**WOKINGHAM
BOROUGH COUNCIL**

Advertisement Consent Consultation

Site Address: Five Guys, Reading Road, Winnersh, Wokingham, RG41 5HG

MEMORANDUM

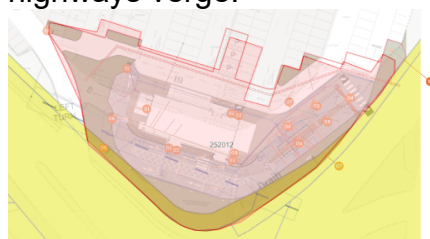
The applicant has confirmed that the updated red line is being reflected on drawing pack P2 of 10 of 188662 (Rev. G).

The locations of the signs have been overlaid with the adopted highways, all proposed signs are to be fixed within the site boundary, with Item 5 being fixed on highways verge.

Despite Item 5 will unlikely reduce the visibility of the junction and there is no technical highway safety concern, the applicant is advised to contact the council's Highway Assets/Legal team to obtain the relevant licence.

Meanwhile, given Item 14 is a panel of 1.7m high being fixed adjacent to two internal junctions, the applicant is required to assess no negative impacts on sightlines and pedestrian visibility.

The application includes multiple internally illuminated signs. All with luminance of 600 cd/m² and display static images. The applicant is required to confirm those images will change no more than once every 10 seconds.

With the proposed illuminated area of signs and totems (except Item 4) to be no greater than 10m², the proposed level of luminance is acceptable.

Meanwhile, the applicant is required to confirm the actual illuminated area of Item 4 to be smaller than 10m². Otherwise, the applicant is expected to reduce the level of luminance to no more than 400 cd/m².
